**Bulli Seam Operations - Appin Mine LWs 709-711 and 905 Extraction Plan (MP08\_0150-PA-46) – post approval assessment**

## Attachment A – EES comments\_Bulli Seam Operations - Appin Mine LWs 709-711 and 905 Extraction Plan (MP08\_0150-PA-46) – post approval assessment

Figure 1. Surface water monitoring for the LW709 to LW711 and LW905 area. Source SLR 2022 Figure 4.

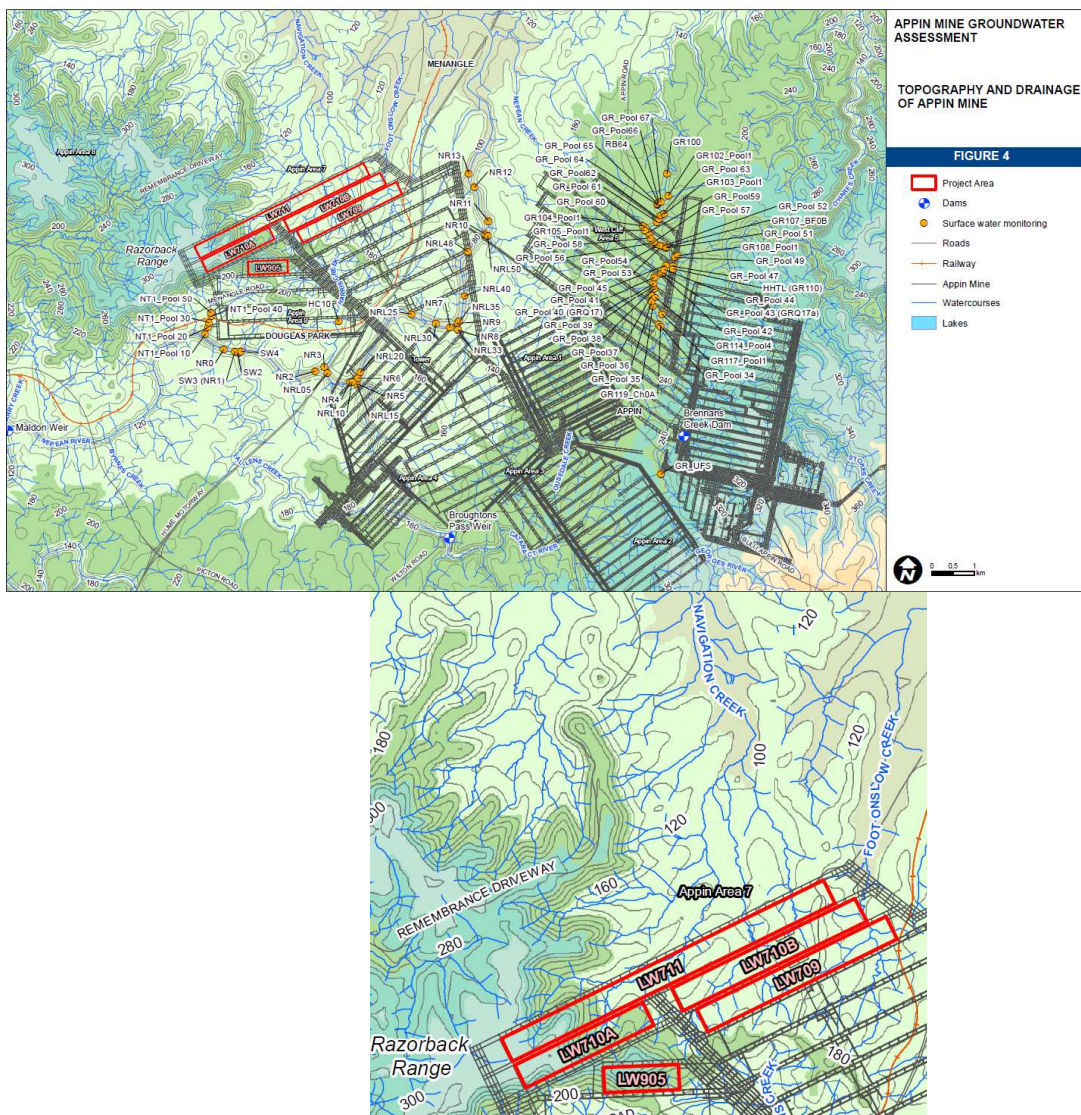
Figure 1 (Figure 4 of SLR 2022) illustrates the surface water monitoring for the area. There are no monitoring sites identified in the 3<sup>rd</sup> order sections of Navigation Creek, Navigation Creek Tributary 1 and Foot Onslow Creek (let alone above any of the longwalls - LW709-711 and LW905).

Prior to approval of the LW709-711 and LW905 Extraction Plan a statistically rigorous, quality assured monitoring program is established for surface pool levels in the undermined 3<sup>rd</sup> order sections of Navigation Creek, Navigation Creek Tributary 1 and Foot Onslow Creek.

Figure 2 Alluvial water monitoring (S2536 only) for the LW709 to LW711 and LW905 area. Source SLR 2022.

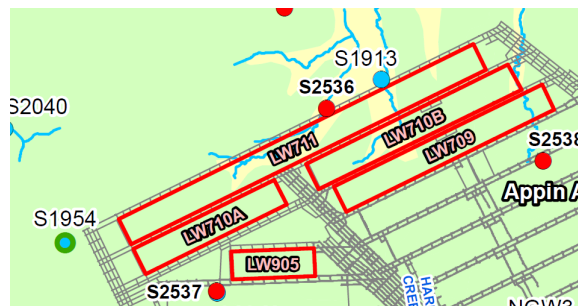
According to the updated Groundwater Assessment (SLR 2022), “S2536 does not have surveyed coordinates”.

Given that there is only one (1) alluvial monitoring bore, its coordinates have not been surveyed and it is cited to be ‘near Navigation Creek’ rather than ‘in Navigation Creek’, EES considers that an inadequate monitoring program for alluvial aquifers occurs in the LW709-711 and LW905 mining domain. S2536 currently has an extremely short period of baseline monitoring (~6 months) and the results from this monitoring have not been supplied/illustrated anywhere in the documentation to support the Extraction Plan.

1. Prior to approval of the LW709-711 and LW905 Extraction Plan a statistically rigorous, quality assured monitoring program is established for alluvial aquifers in the undermined 3<sup>rd</sup> order sections of Navigation Creek, Navigation Creek Tributary 1 and Foot Onslow Creek.
2. The raw data and surveyed coordinates for S2436 are forwarded to EES.

Figure 3 Groundwater monitoring for the LW709 to LW711 and LW905 area. Source SLR 2022 Figure 9.

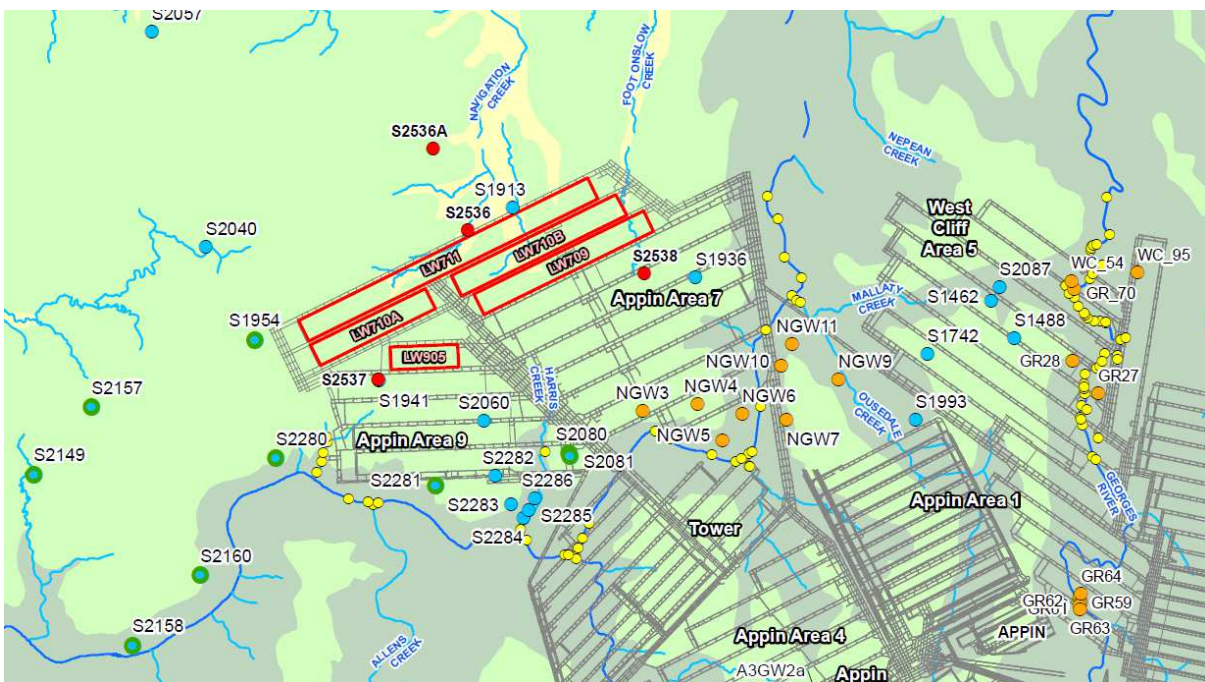
The most significant issue from Figure 3 is that it appears<sup>6</sup> there are no groundwater monitoring bores directly above LW709-711 and LW905. Review of End of Panel reports and Annual Reports as well as later figures in SLR (2022; e.g. Figure 45), however, identify a number of piezometers above the longwalls (Figures 4 and 5), many of which have not been included/discussed in detail in the Groundwater Impact Assessment (SLR 2022) report.

<sup>7</sup> It is noted that Figure 9 of SLR 2022 still does not identify S2308 lying above LW710B.

1. Prior to approval of the LW709-711 and LW905 Extraction Plan a statistically rigorous, quality assured monitoring program is established for groundwater monitoring in the area.
2. A proper BACI analysis is conducted on all (not a selective subset of) groundwater monitoring bores to assess the putative impacts of mining on groundwater levels.
3. The raw data and surveyed coordinates for all groundwater monitoring bores are forwarded to EES.
4. Scientific evidence be provided to support the currently unsupported contention that groundwater extraction from landholder bores leads to a sustained decline of 10-40m in aquifer levels independent of mining.

Figure 5 Groundwater monitoring for the Appin 700 area. Source Geoterra 2018.

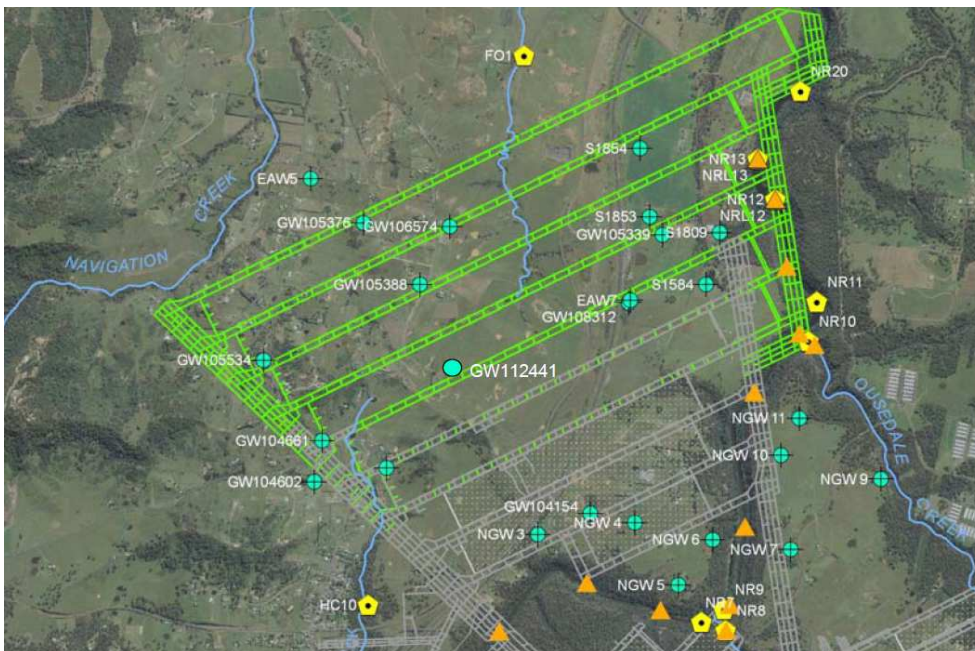
In particular, the Groundwater Impact Assessment (SLR 2022) provides no or very limited information or data on S1763, S2315, S2524, S1947, S1957, S2060, S1864, S1853, S1584, S1809, S1854. It is difficult to find any information on S1864, S1853, S1584, S1809 and S1854, despite them being listed as monitoring bores in end of panel reports.

Figure 13 Hydrograph – S2308

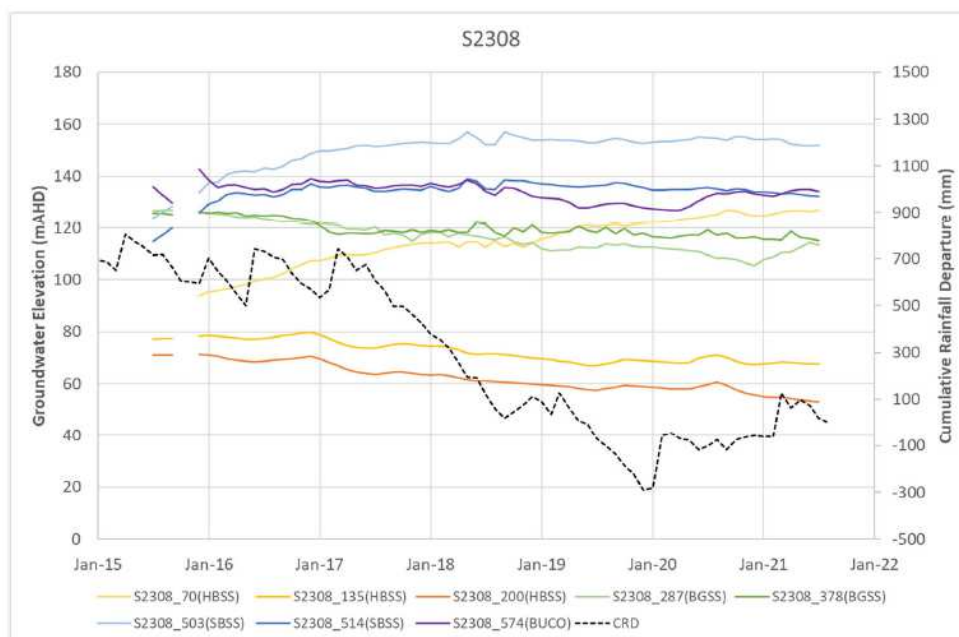
It appears that the Hawkesbury sandstone aquifers in S2308 have potentially been directly affected by mining, with declines of ~10m (135m and 200m sensors), but there is no statistically rigorous assessment of the data (i.e. there is no BACI design assessment).

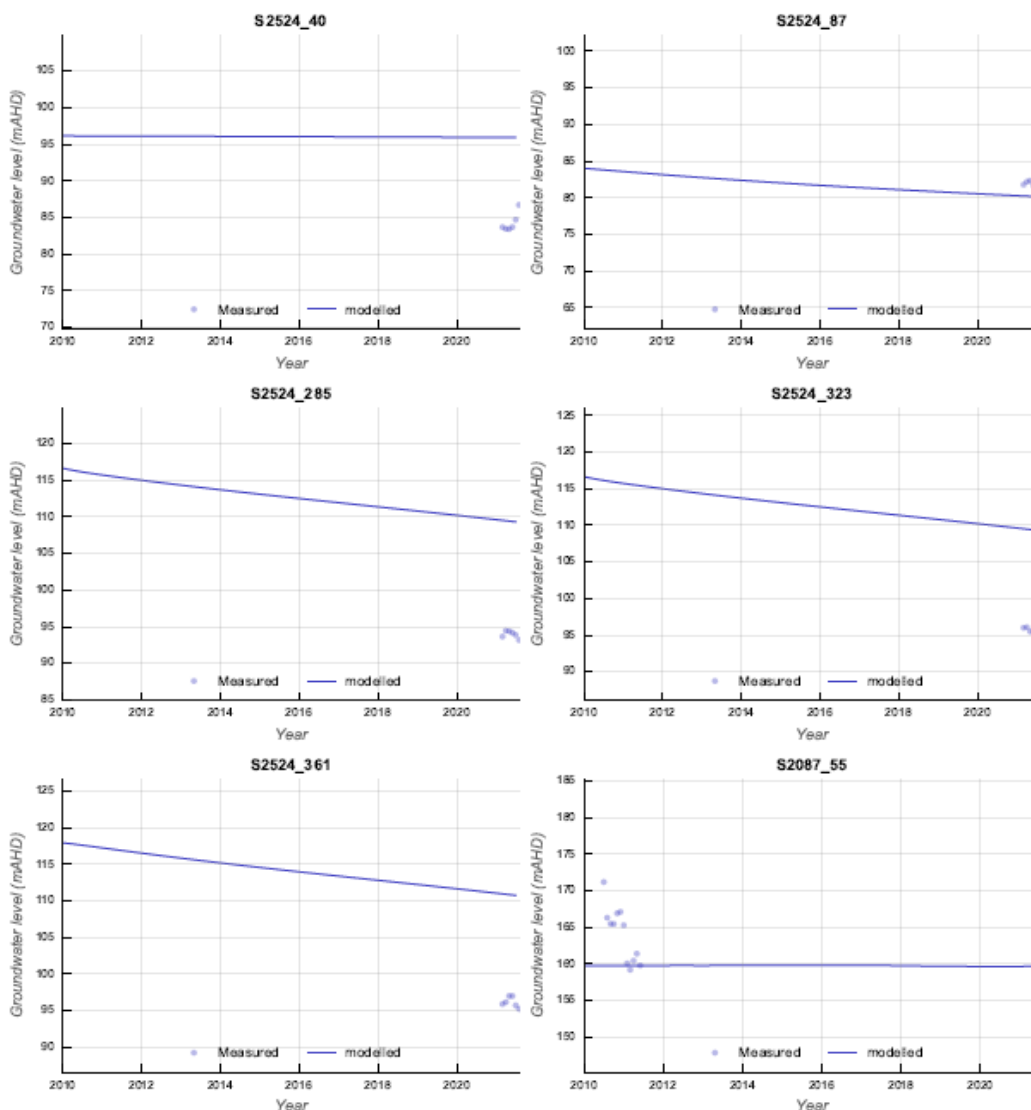
- S2315 - which lies directly above LW711. Figure 9 of SLR 2022 does not identify bore S2315, however it does appear in SLR (2022) Figure 45.

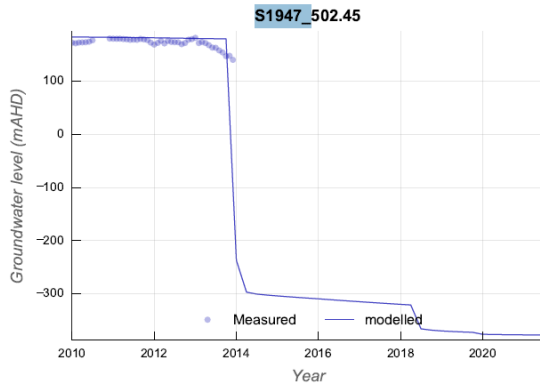
- S2524 – at the northern end of LW711. Data appears to exist from mid-2020 but this receives no discussion in the report. No recent data has been supplied/presented. Note the poor agreement between modelled and observed data, with observed groundwater often being 10-15m below model predictions.

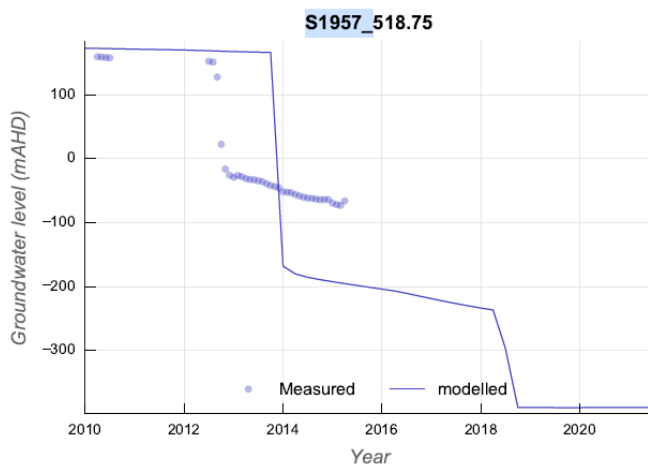
- S1947 – lies at end LW902. No recent data has been supplied/presented.

Figure 25 Hydrograph – S2060

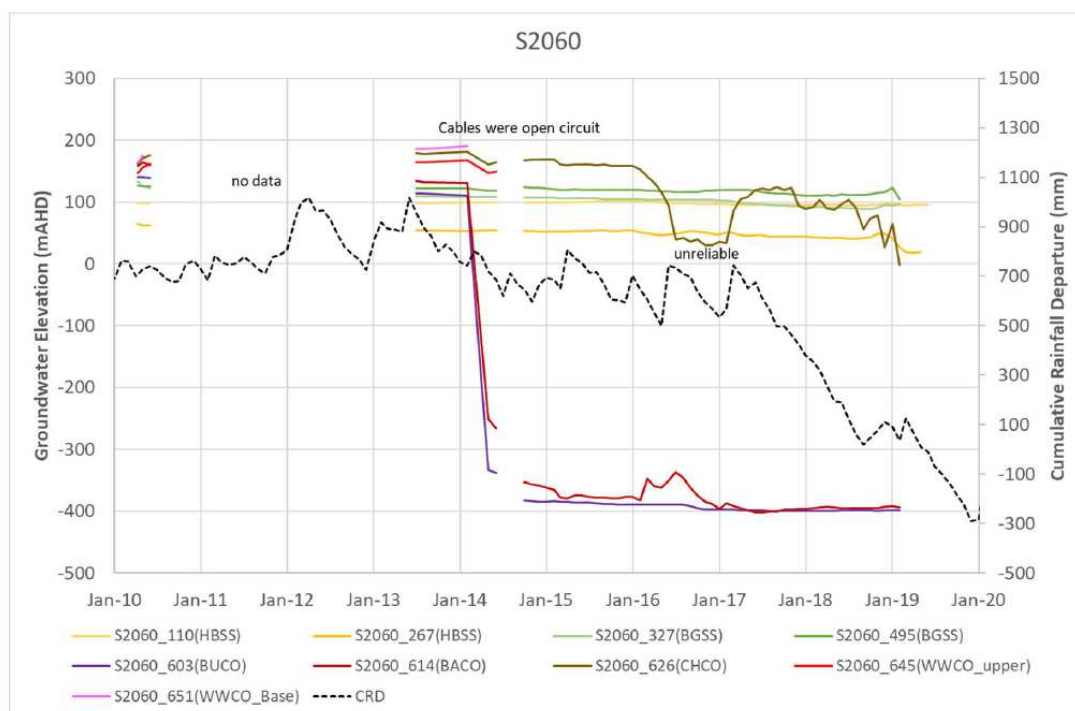
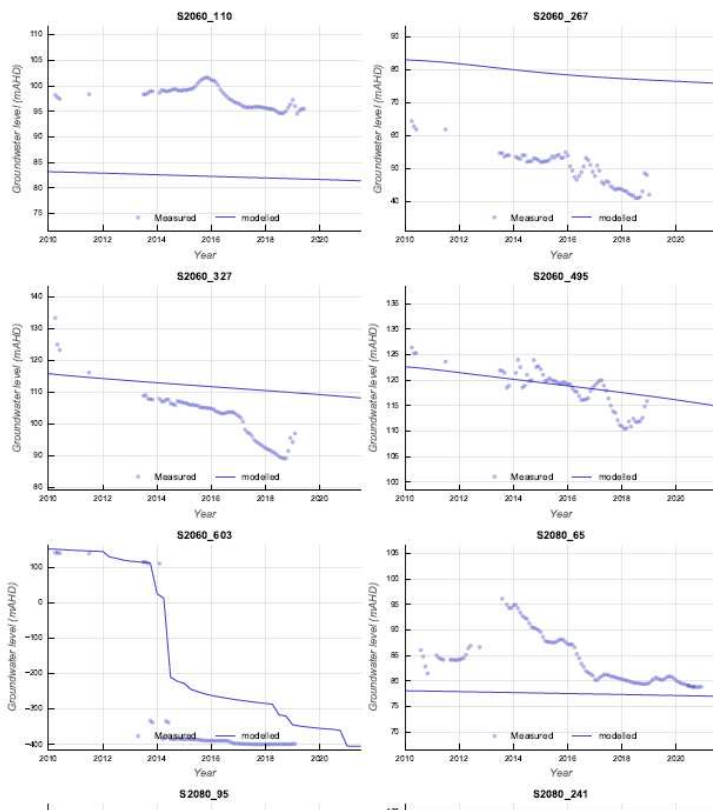
- S2060 – lies above LW902. No recent data has been supplied/presented, but the declining trend in aquifer levels is obvious in Appendix D<sup>11</sup>.

<sup>11</sup> Less so in Figure 25 of SLR (2022) which also indicates 'unreliable data'. No explanation is given for why it is considered 'unreliable' or why it is not potentially a 'real' mining impact.

Figure 24 Hydrograph - S1941

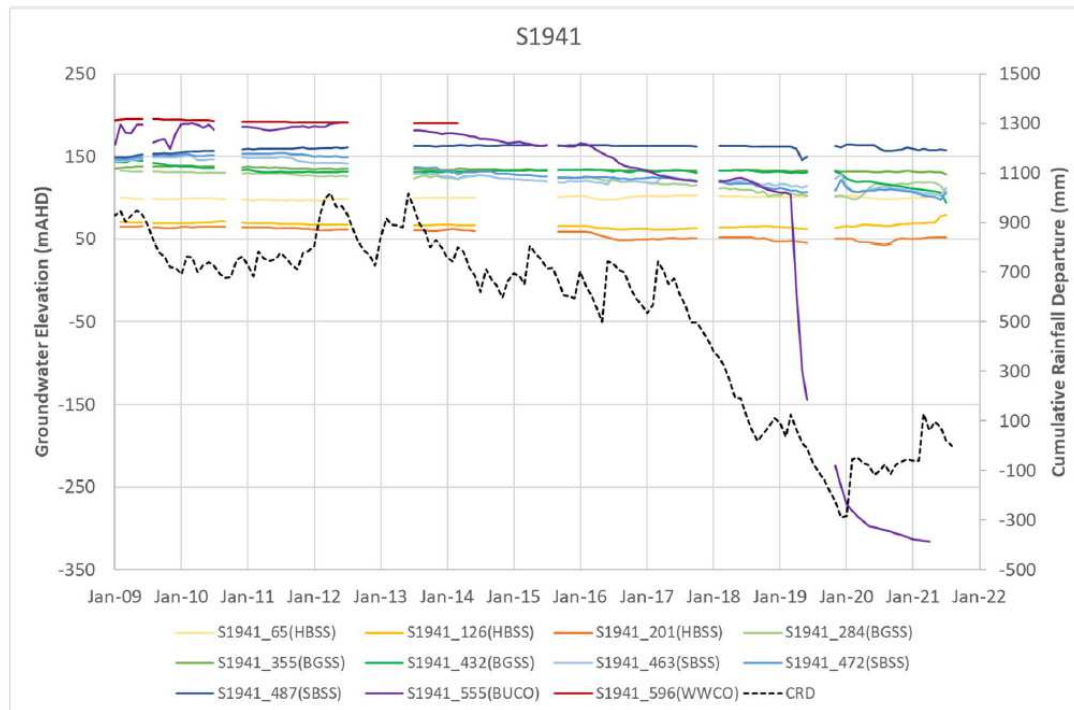
- S1941 – lies above LW904. Note the poor agreement between modelled and observed data, with observed groundwater often being 10-50m below model predictions. This could quite conceivably be indicative of a longwall mining impact given S1941 lies directly above LW904.

Figure 22 Hydrograph - S1936

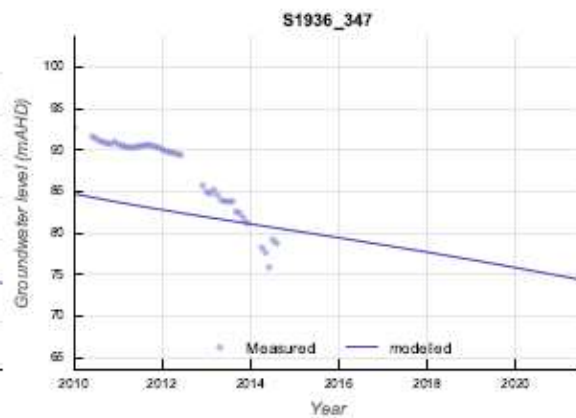
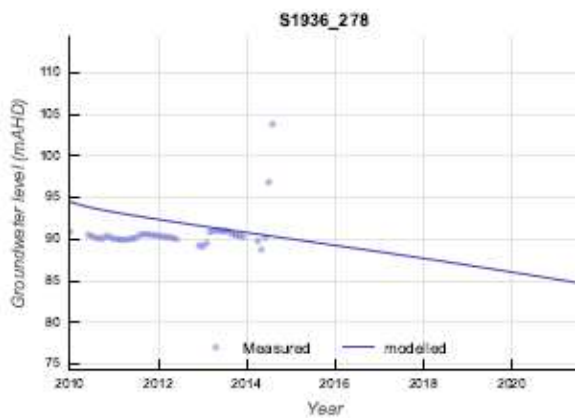
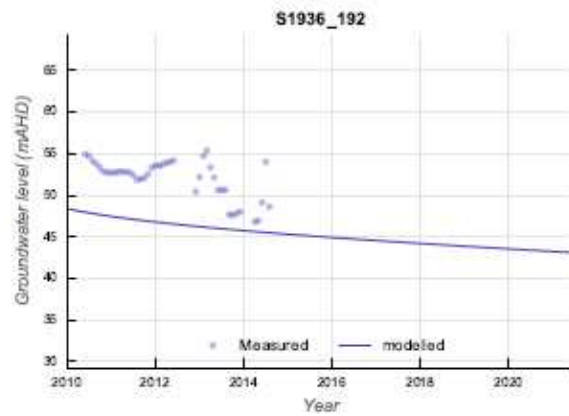
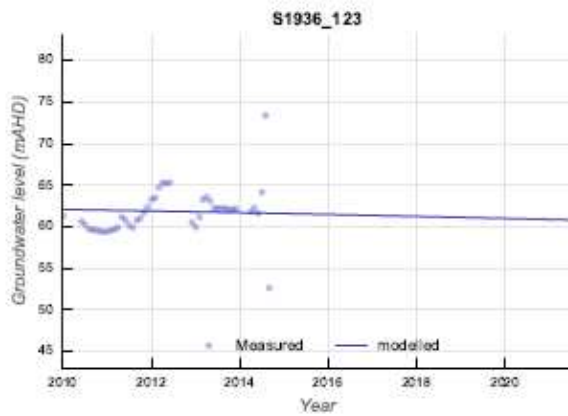
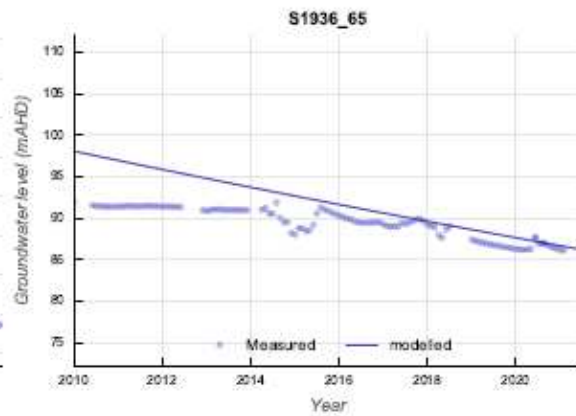
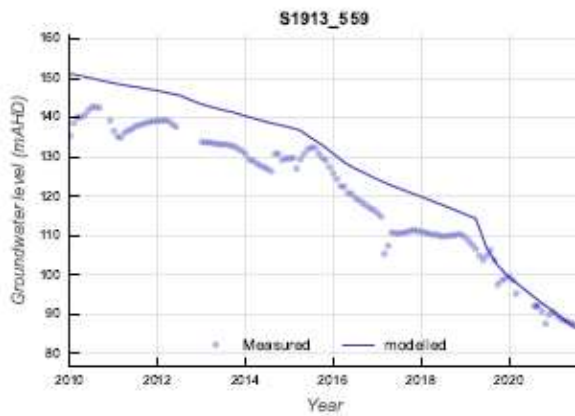
This summary does not identify that the 65m Hawkesbury sandstone sensor indicates water levels have declined by ~7m since monitoring began.
